James + Jean S. Bradley  
 308 West E St.  
 Sumner, NC 28389  
 910-890-9024  
 910-658-6457

PROPOSED  
ADDITION

PROPOSED  
STRUCTURE

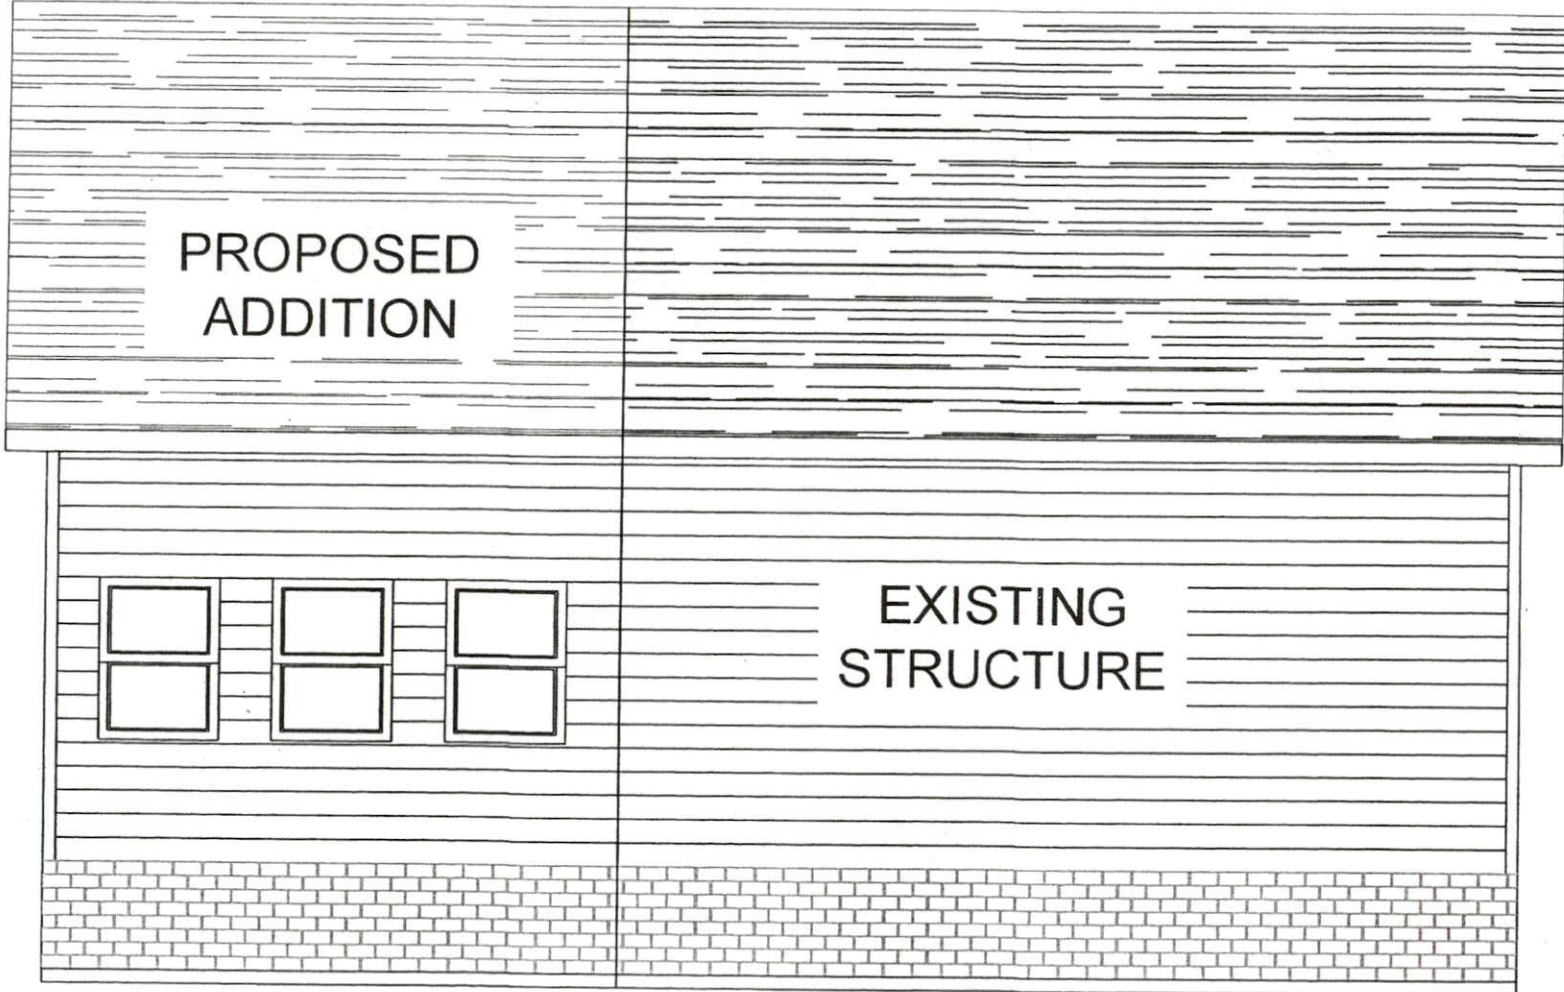
2x10 @ 16" oc min  
for this span

~~2x8~~ CONTINUOUS  
RIM JOIST

~~2x8 FLOOR JOIST~~  
@16" O.C. WITH  
BRIDGING (TYP)

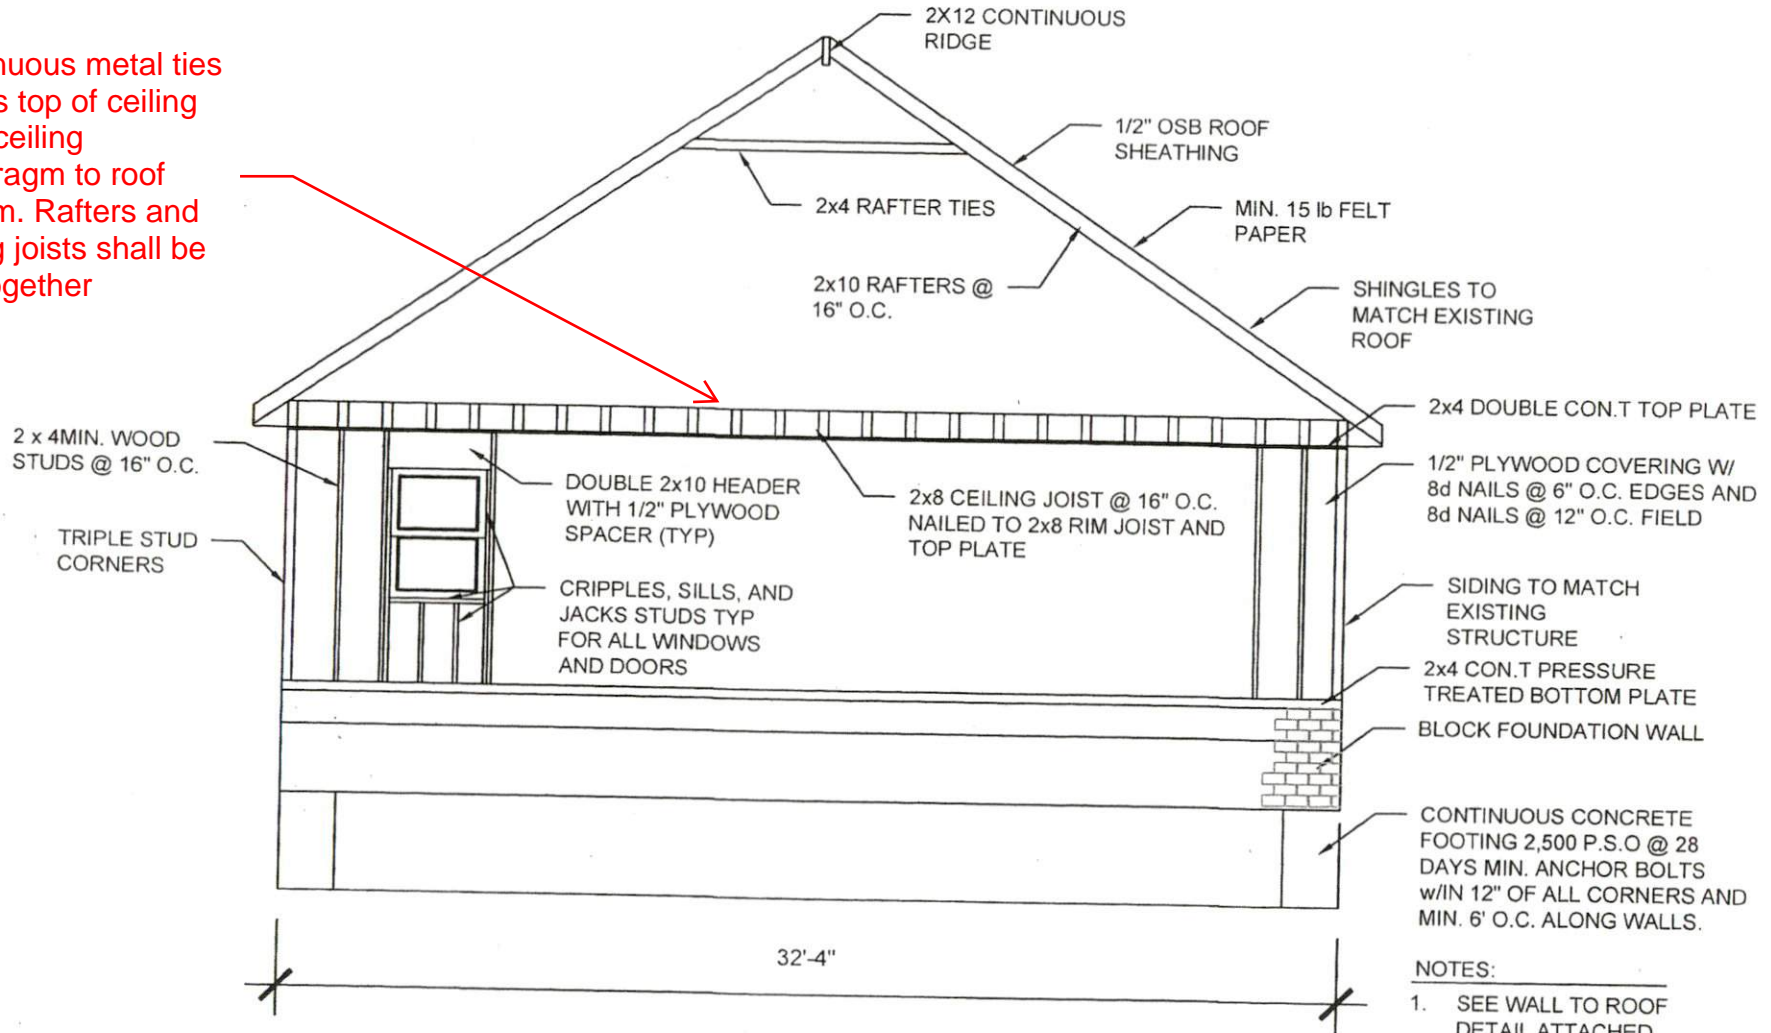
Continuous metal ties across top of ceiling to tie ceiling diaphragm to roof system. Rafters and ceiling joists shall be tied together
